1001 MINOR
DESIGN REVIEW BOARD

18 NOVEMBER 2015
DPD #3019363

PROJECT INFORMATION

ADDRESS: 1001 MINOR AVENUE

5. MATERIALS

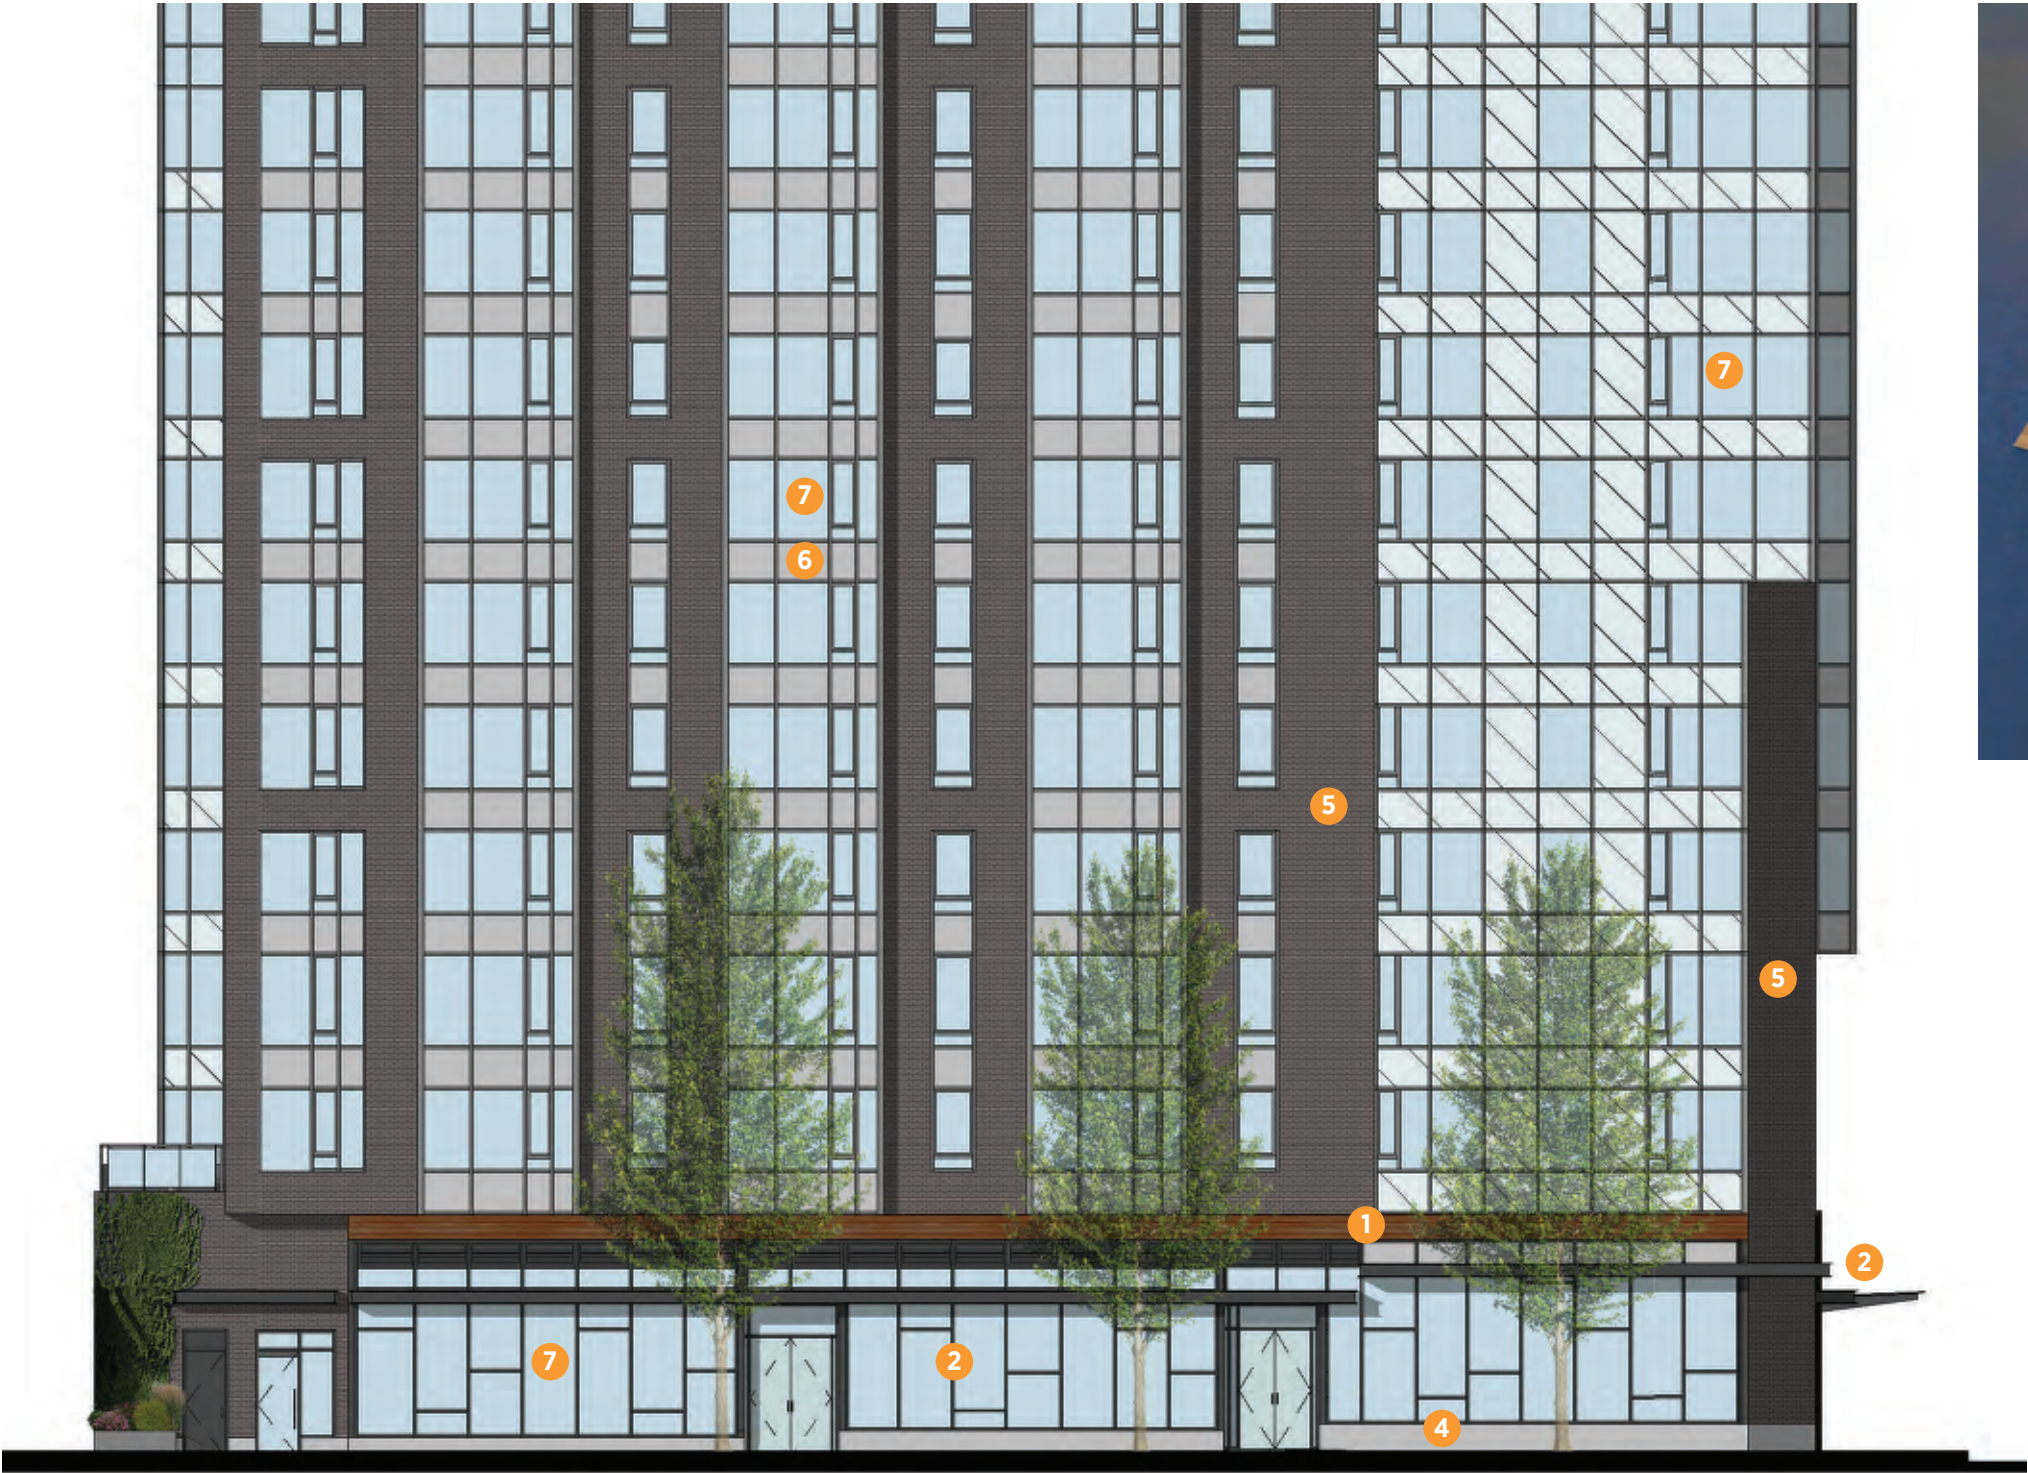
"The Board expressed support for the materials concept and precedent images, including high contrasting application of brick and glass to further emphasize the massing and architectural concept."

"The Board reiterated the importance of using strong, high quality materials and directed the applicant to ensure the materials were contextually compatible with the surrounding development."

The building has been developed with high quality materials as supported by the Board at EDG. High contrasting materials have been used, but the variety of applications has been simplified to support the preferred massing concepts, and board's direction.
